## Review 1

Braided rivers can provide substantial recharge to regional aquifers, with flow exchange between surface water and groundwater occurring at a range of spatial and temporal scales. However, the difficulty of measuring and modelling these complex and dynamic river systems has hampered process understanding and the upscaling necessary to quantify these fluxes. This is due to an incomplete understanding of the hydrogeological structures which control river-groundwater exchange. This paper presents a new conceptualization of subsurface processes in braided rivers based on observations of the main losing reaches of three braided rivers in New Zealand. It is useful to understand the braided river systems.

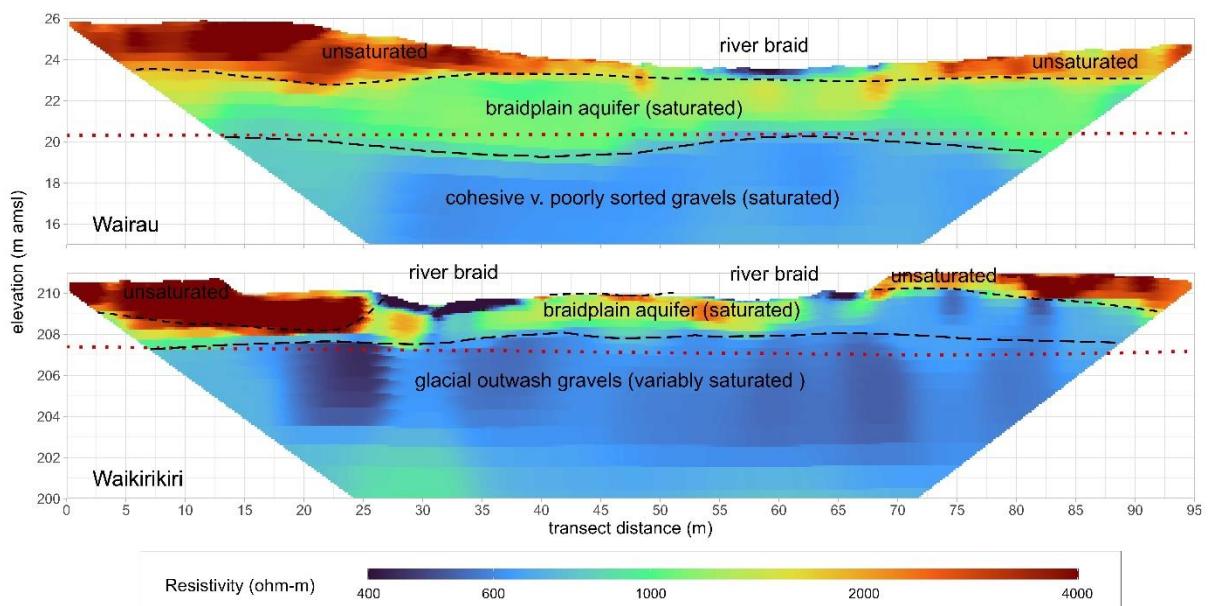
1. Figure 9 in page 22, please explain that why the “glacial outwash gravels” are unsaturated?

And how about the braidplain aquifer? Saturated or unsaturated?

Can you compare the ERT results with your borehole surveys in Fig. 4.

There is an error on the text in Fig. 9 which should say “variably saturated”. We’ve corrected this, and have also modified Fig 9. to clarify the saturation status:

The requirements for a variably saturated zone to form in the sediments underlying the BPA are described in the paragraph at line 172. For clarification, we will include the following explanation in the text at line 342:

Our explanation for the presence of this variably saturated zone is that the glacial outwash gravels are stratified, and vertical infiltration to the regional aquifer is limited by the lower permeability horizons of silt and clay. The presence of higher permeability horizons within the stratified postglacial sequence allows water to move laterally away from the recharge zone at a rate that exceeds vertical infiltration, enabling unsaturated or variably saturated conditions to form.

We've added a sentence at line 154 to clarify the BPA saturation status:

For a perennially flowing river, the BPA will retain some degree of saturation, although unsaturated conditions may occur in the case of intermittent or ephemeral rivers if there are prolonged periods with no river flow.

The contact at the base of the BPA shown on Fig 9 represents the unconformity revealed in drill core e.g. on Fig 4, and is described in section 5.1, including the grainsize distribution of the two units (Fig 5). While the locations of the ERT profiles don't exactly match the coring locations (Fig 3), there is structural and lateral consistency in both the coring and ERT data. We've added an interpolated surface to Figure 9 (see red line in the figure above), which has been derived by kriging intercepts of BPA base within the contemporary braidplain (in Fig 3). The sentence at line 457 has been modified for clarity:

These profiles reveal the contact between the braidplain aquifer and underlying sediments (the unconformities shown in Fig. 4) at elevations consistent with drillhole coring. For comparison, the elevation of the same unconformity, derived by kriging intercepts of the BPA base within the contemporary braidplain (Figure 3), is shown in red on Figure 9.
